From: Chowdhury, Abu Sayem
Sent: Wednesday, 7 November 2018 3:19 PM
To: EPD, Customer Services
Cc: TCCS_PC DACOORD; Bell, Jeff
Subject: COMM-TCCS-201834203-23/346 KAMBAH-01 [SEC=UNCLASSIFIED]

DEVELOPMENT APPLICATION NO: 201834203

PROPOSAL FOR ALTERATIONS AND ADDITIONS TO EXISTING COMMERCIAL DEVELOPMENT – partial demolition of the existing commercial building, alterations and additions to the existing commercial building, landscaping, and associated works.

BLOCK: 23	SECTION: 346	SUBURB: Kambah
------------------	---------------------	-----------------------

Project Name and Location			
KAMBAH SHOPPING VILLAGE			
BLOCK 5 SECTION 346			
Drawing Title			
VEHICLE TURNING PATHS			
PLAN SHEET 4			
Project Number	Type	Discipline	Sub-Discipline
150752	DRG	CIV	TP
Drg No.	Rev		
2204	B

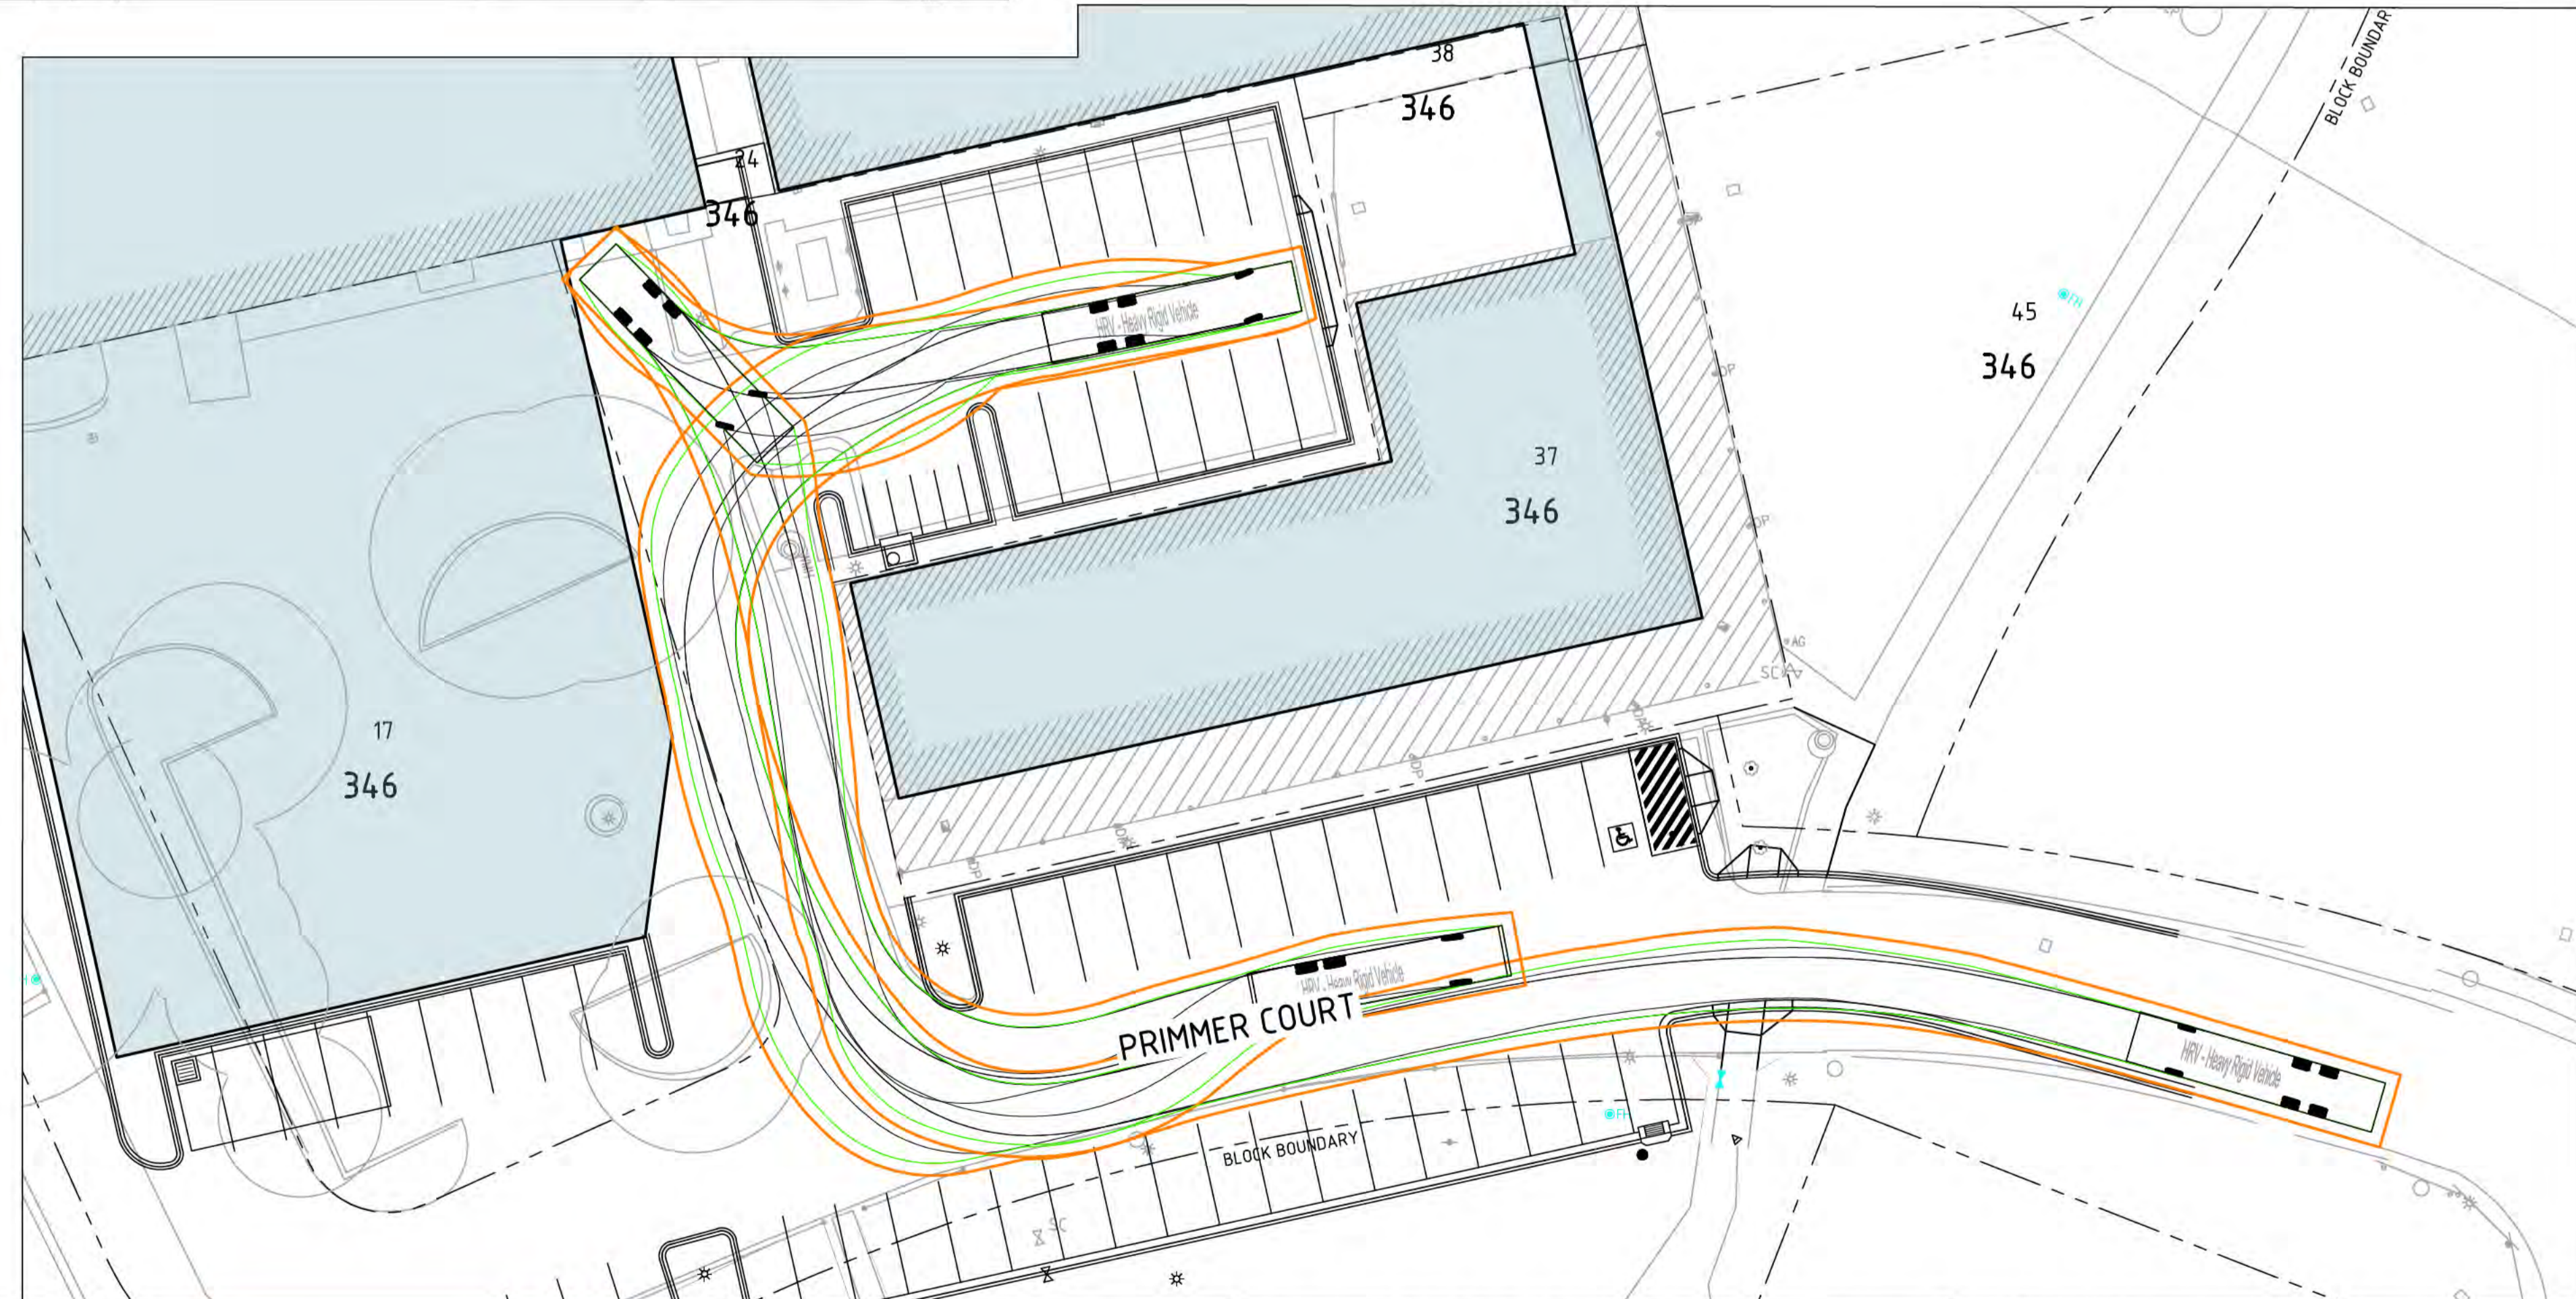
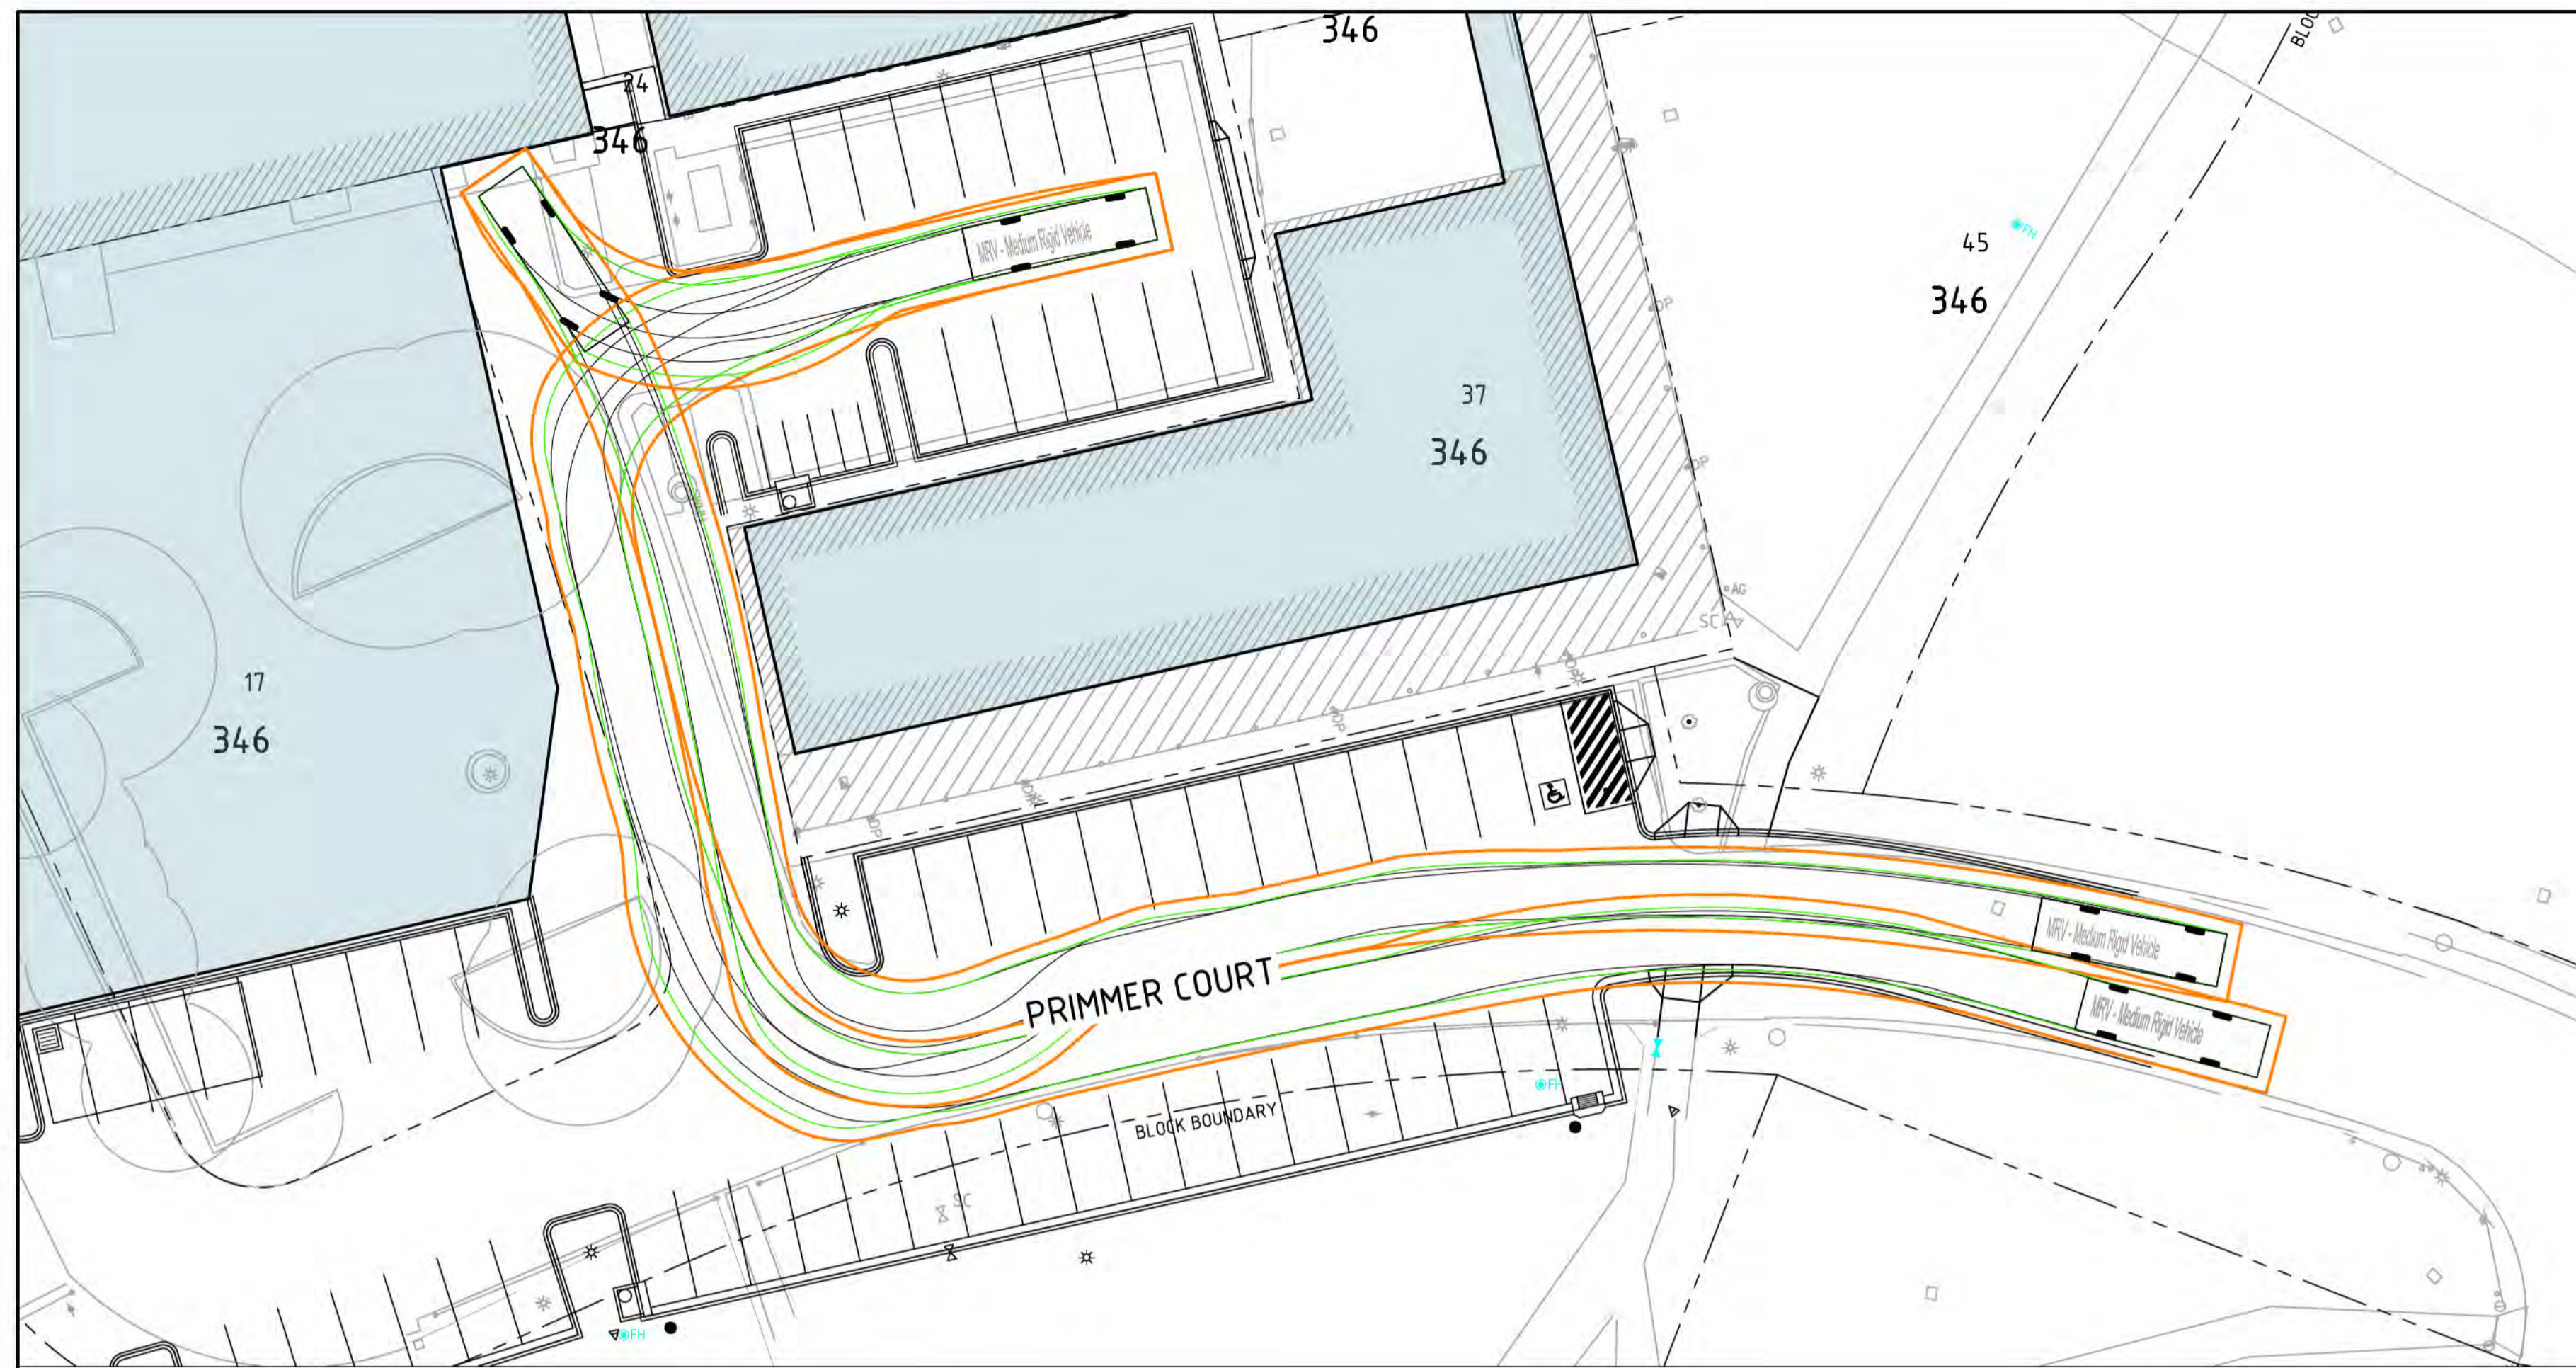
Please note that TCCS received attached drawings (2204 & 2205) from Canberra Town Planning and these drawings must be considered as DA documentation
